Re: Response to the Agriculture, Fisheries and Conservation Department Submission

Proposed Temporary Holiday Camp, Place of Recreation, Sports or
Culture (Hobby Farm), Field Study/Education/Visitor Centre, and
Public Vehicle Park (excluding Container Vehicle) for a period of 3 years
in “Village Type Development”, “Recreation (1)”, and the areas are
shown as ‘Road’ of various Lots in D.D 41 and the adjoining
Government Land, Sha Tau Kok, New Territories.

**Response to the Agriculture, Fisheries and Conservation Department
(AFCD)**

Subject: Re: Application No. A/NE-STK/32 - Submission - Further Response to LCSD

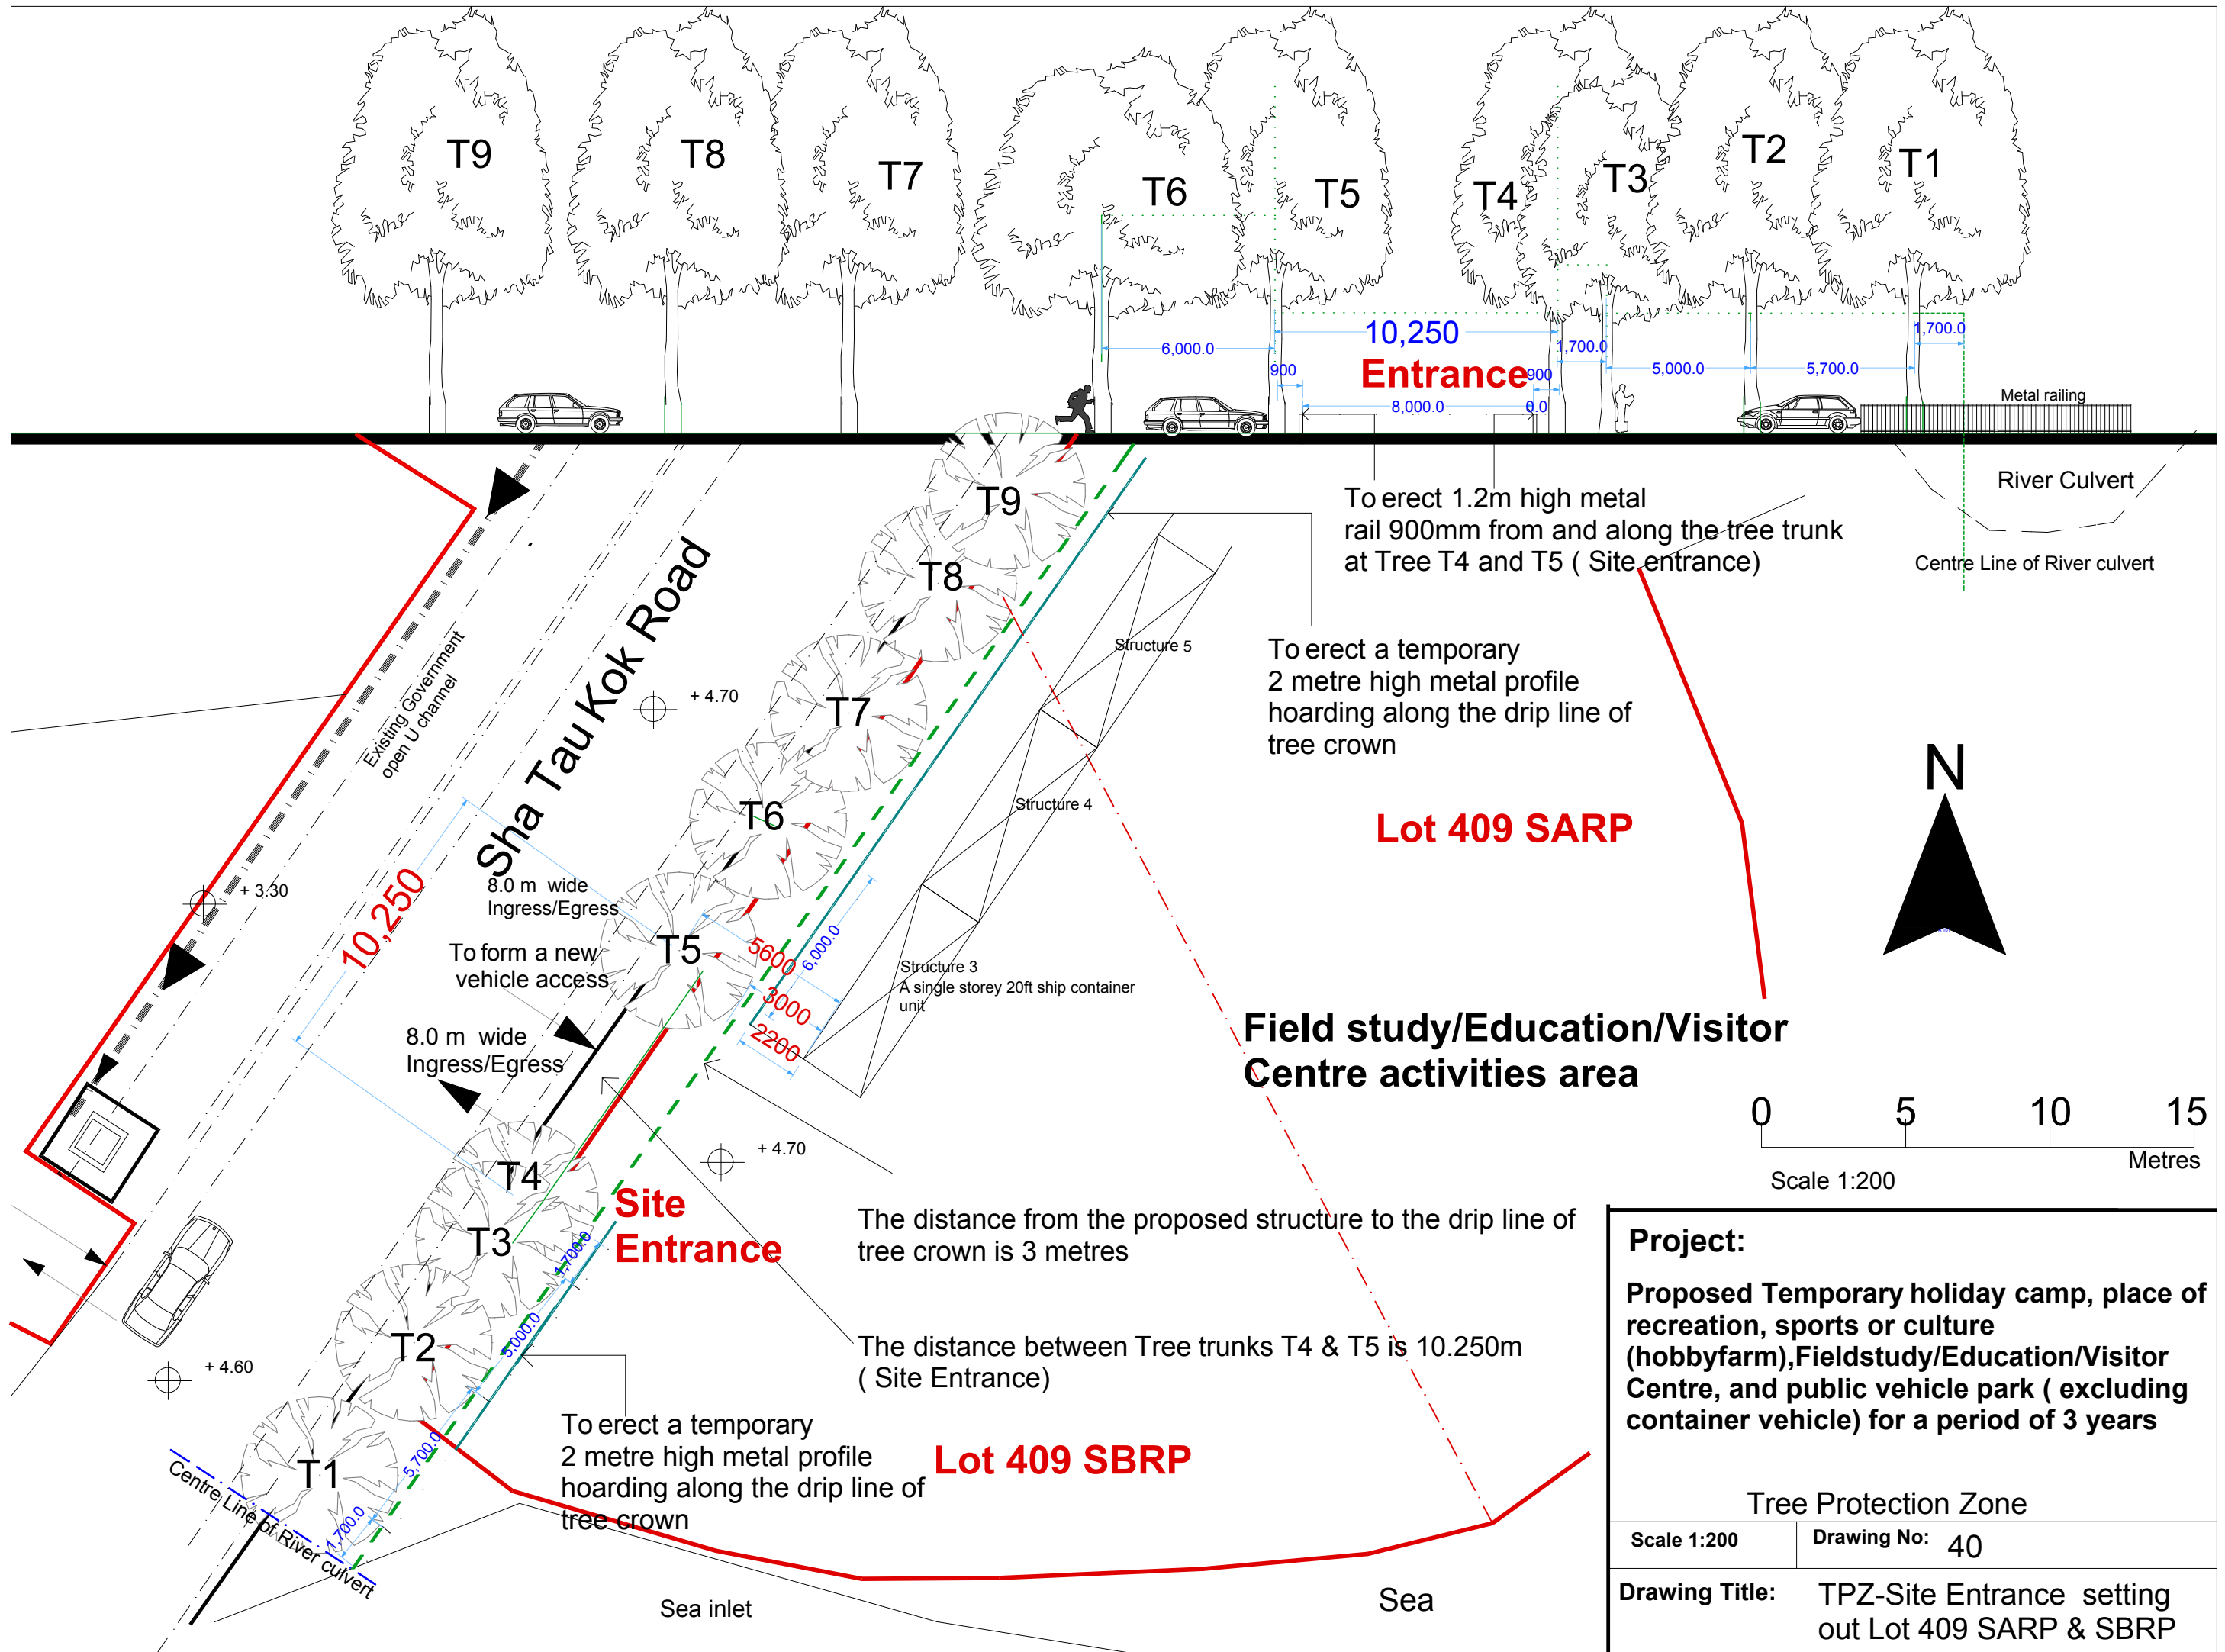
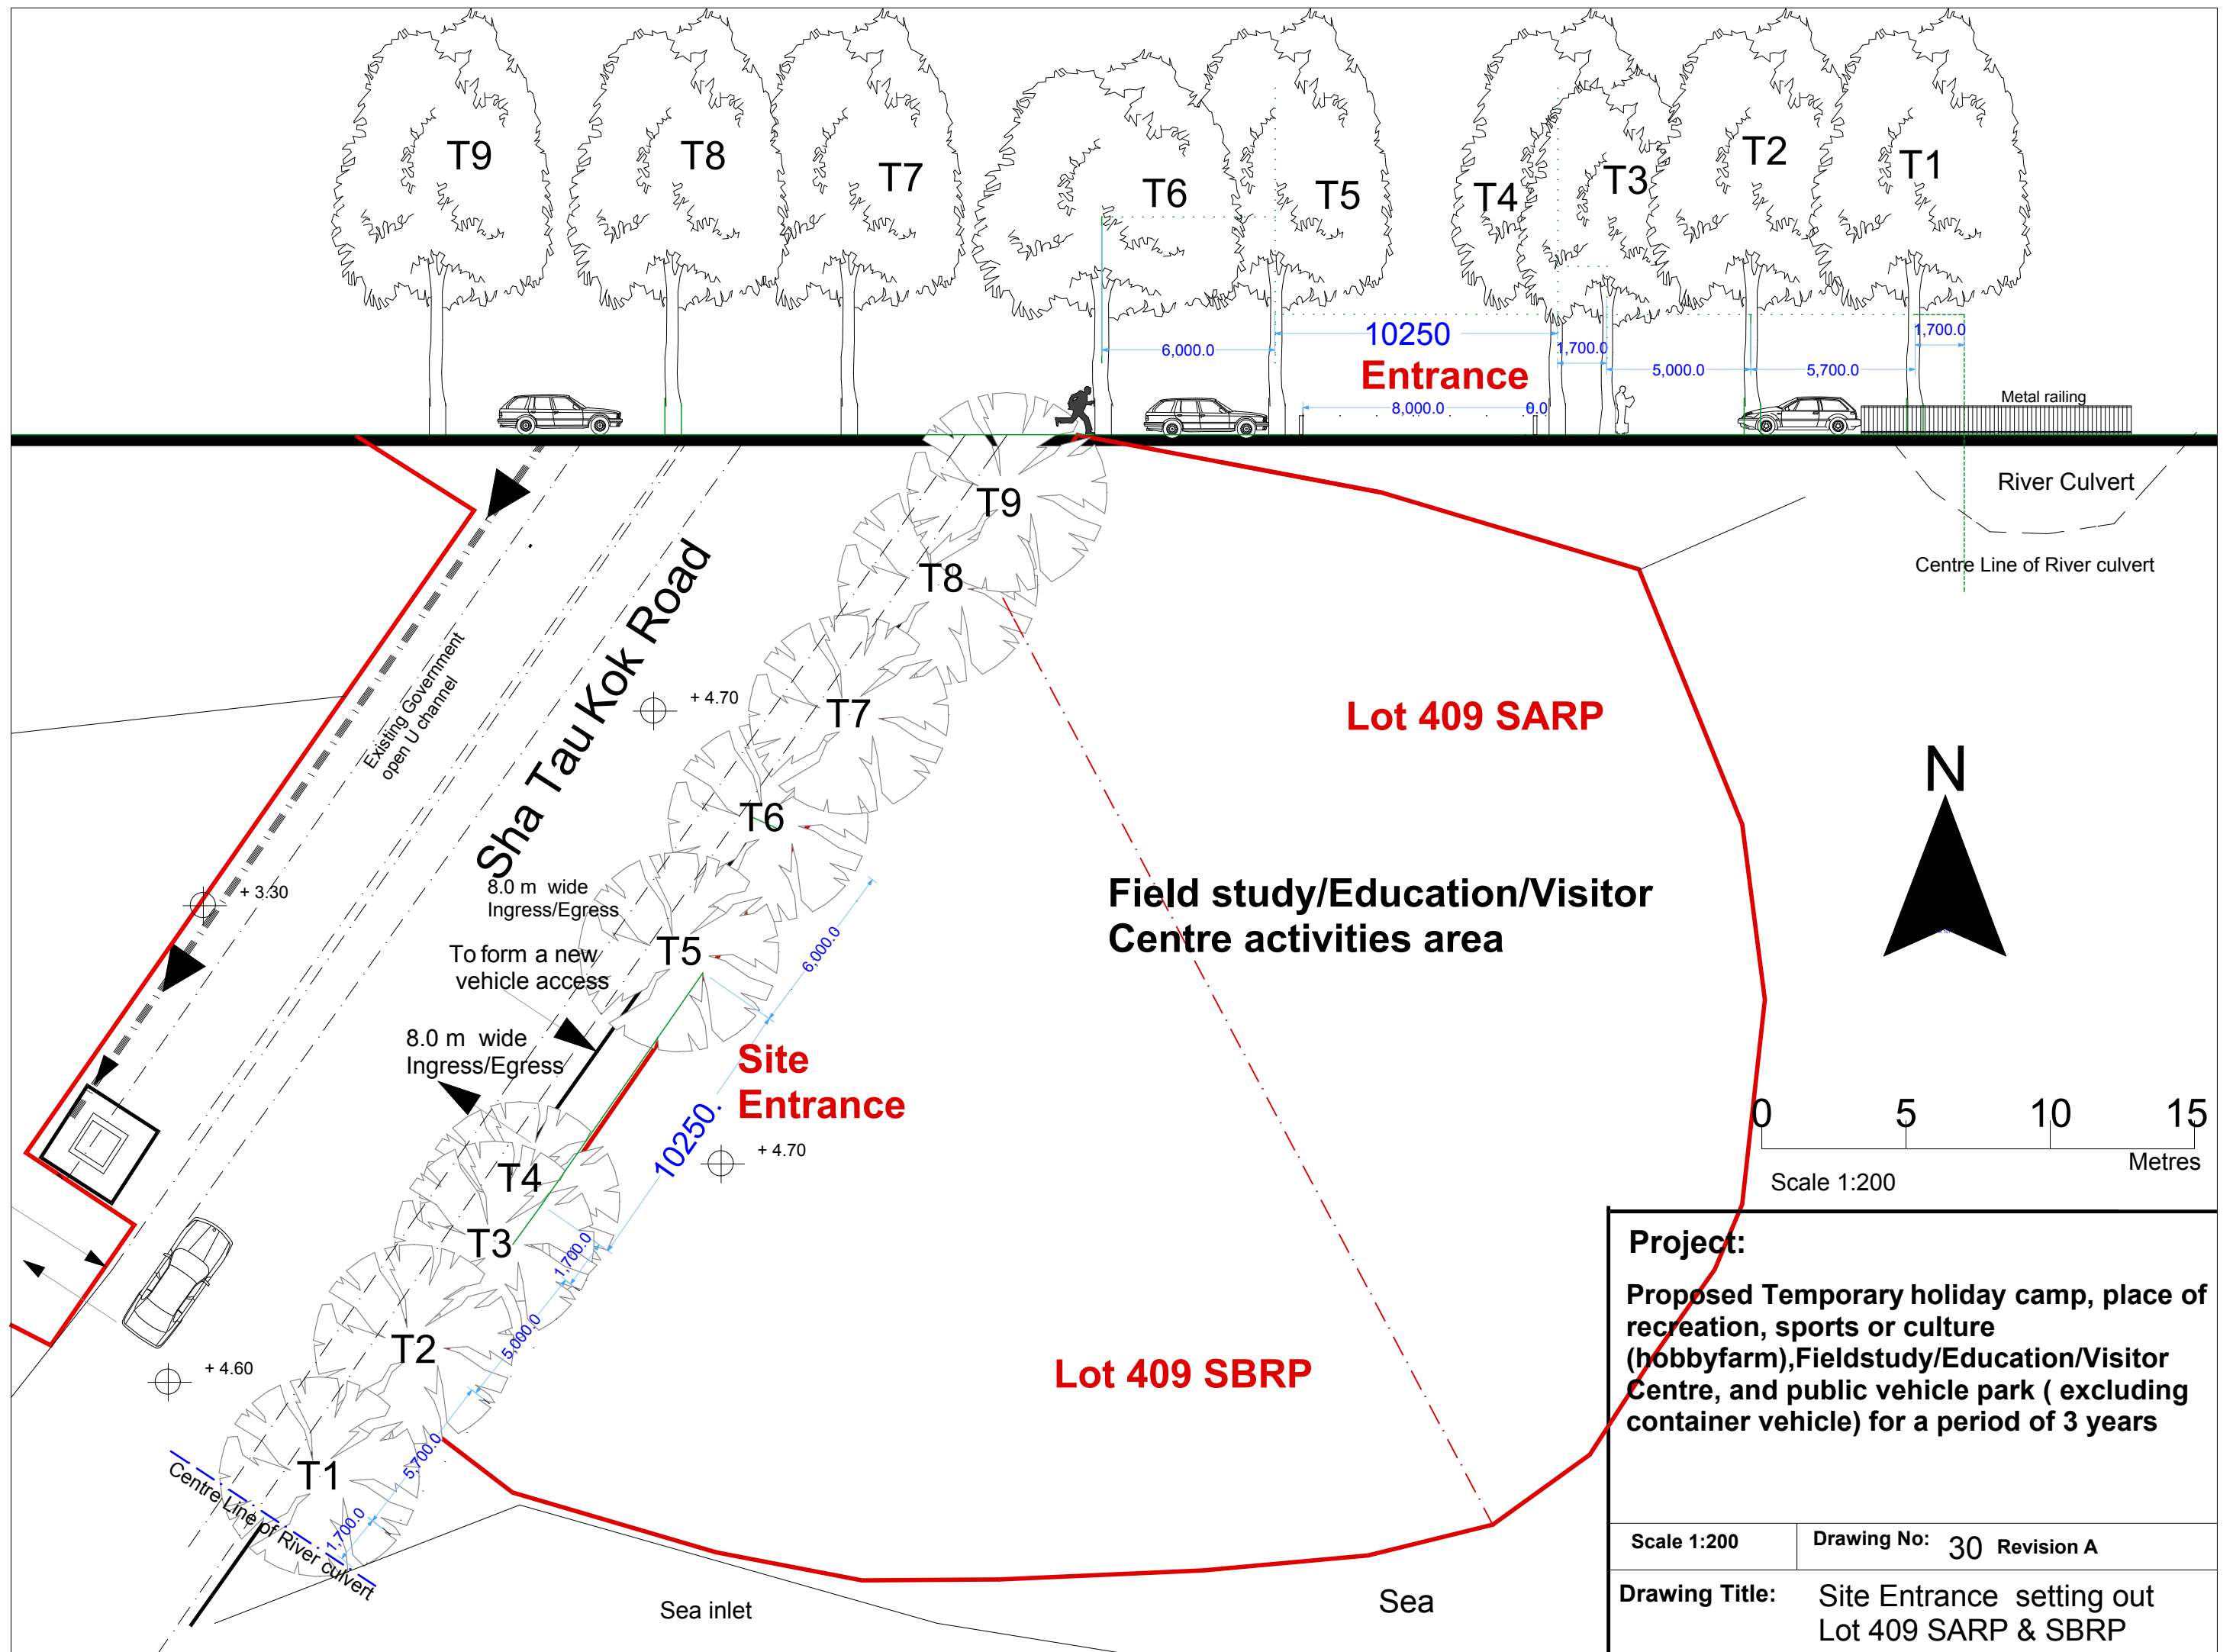
- (a) The applicant should elaborate on what measures will be implemented to avoid adverse impacts on the surrounding environment, including nearby trees, watercourses and mangroves as far as practicable; and
- (b) The applicant should consider relocating the proposed structures (e.g. Structures 3 to 6) away from the above-mentioned ecological resources, preserving trees within the application site as well as providing hoardings, screen planting and/or boundary wall.

The distance from the proposed relocated single-storey structures to the drip line of the tree crown will be approximately three (3) meters.

To protect and preserve trees and the suburban area where the Application Site is located, during the construction phase, a temporary, two meter high, metal profile hoarding along the drip line of the tree crown will be erected. In addition, a 1.2 meter high, metal rail will be placed on both sides of the site entrance. When the Application Site is in operation, the temporary hoarding will be upgraded to a more durable and sustainable uPVC Composite Fencing. Please refer to the Site Entrance Setting Out and Tree Protection Zone – Site Entrance Setting Out drawings submitted herewith.

The proposed structures are relocated to keep them away from the mangroves, and hoardings will be erected to screen off the site perimeter from the mangroves during site building.

Appendix 1

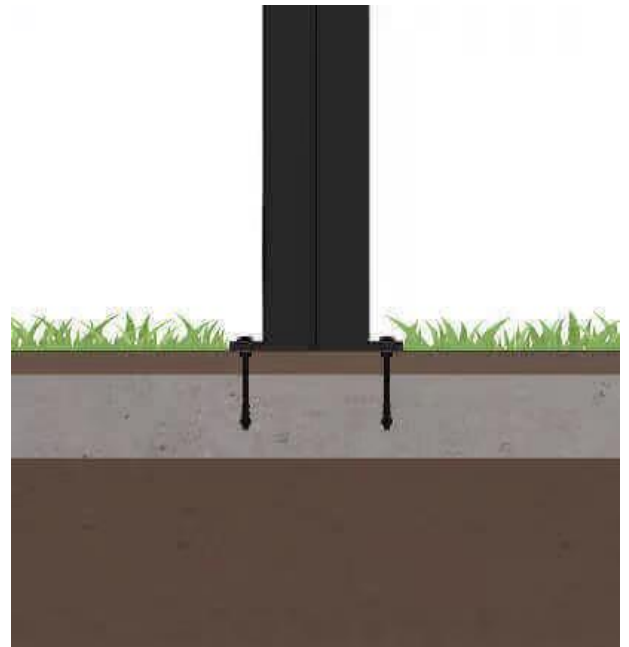
Please advise the installation method of the 2 metre high metal profile hoarding along the drip line of tree crown and 1.2 metre high metal rail 900 mm from and along the tree trunk at Tree T4 and T5 and whether excavation work will be required for the installation. In general, all trenches should be at least 1.5 m away from any tree within 250 mm Diameter at Breast Height (DBH) or at least 6 times the DBH of any tree if their DBH exceeds 250 mm. Any excavation within 2.5 m or falls within the drip line of a tree must be done by hand and that no roots of 25 mm dia. or above may be severed. The applicant should also observe to “Tree Care during Construction” issued by Tree Management Office during planning stage and the whole course of the work.

The 1.2 metres and 2 metres site temporary hoarding and metal rail mesh fence panels are either fixed with a solid, heavy-duty rubber foot locking block or freestanding; no excavation work is required for these erections. Please see photos of Fences in Appendix 1.

The proposed 1.8m L x 1.8m H new fencing system is fixed and supported by two surface-mounted fence posts. A shallow concrete footing, approximately 0.2m in width x 0.25m in Depth, is required. Please see photo of surface-mounted fixing in Appendix 1.
